PAID
HEATER DRAIN (HD)
SARGENT & LUNDY
DRAWING NO.
M-28 Sht. 3
M-28-3

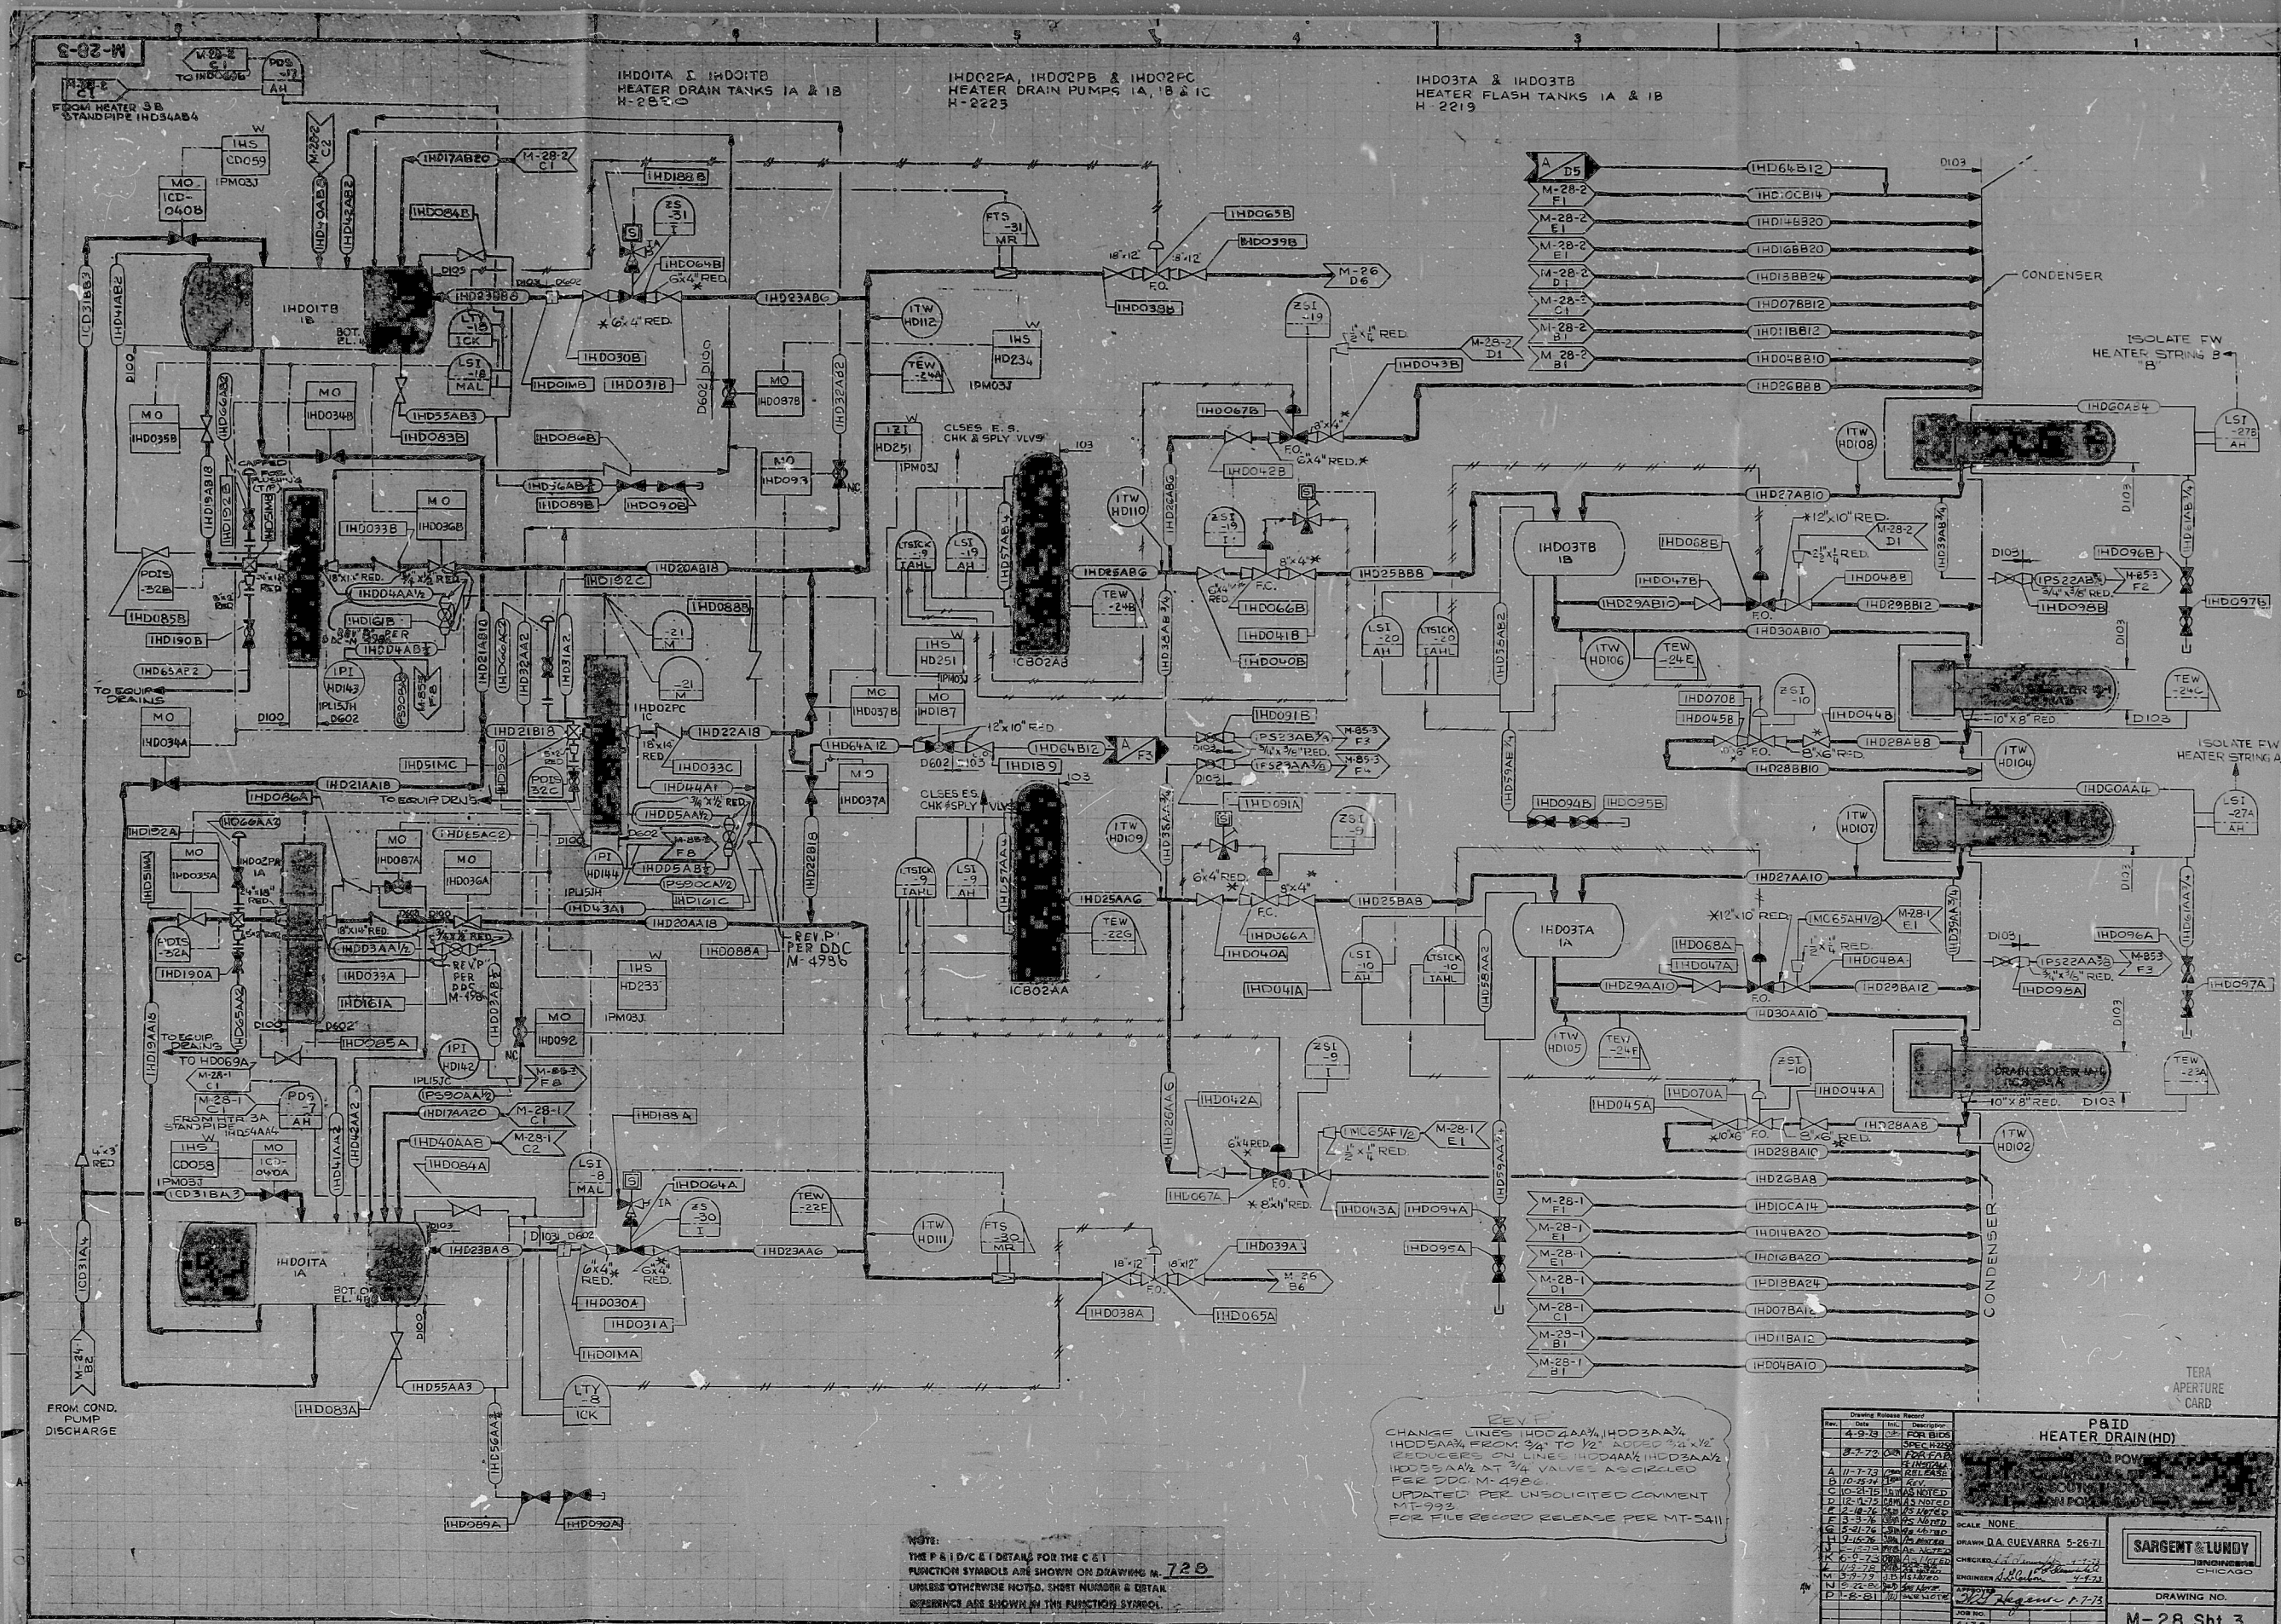
CHANGE LINES IHD02AA, IHD03AA, IHD05AA, FROM 3/4" TO 1/2" ADEQ 3/4" X 1/2"
FLOWERS ON LINE IHD02AA, IHD03AA, IHD05AA
AT 3/4" VALVE ASSIGNED
PER PDC M-498
UPDATED PER UNLOCATED COMMENT
FOR FILE RECORD RELEASE PER MT-5411
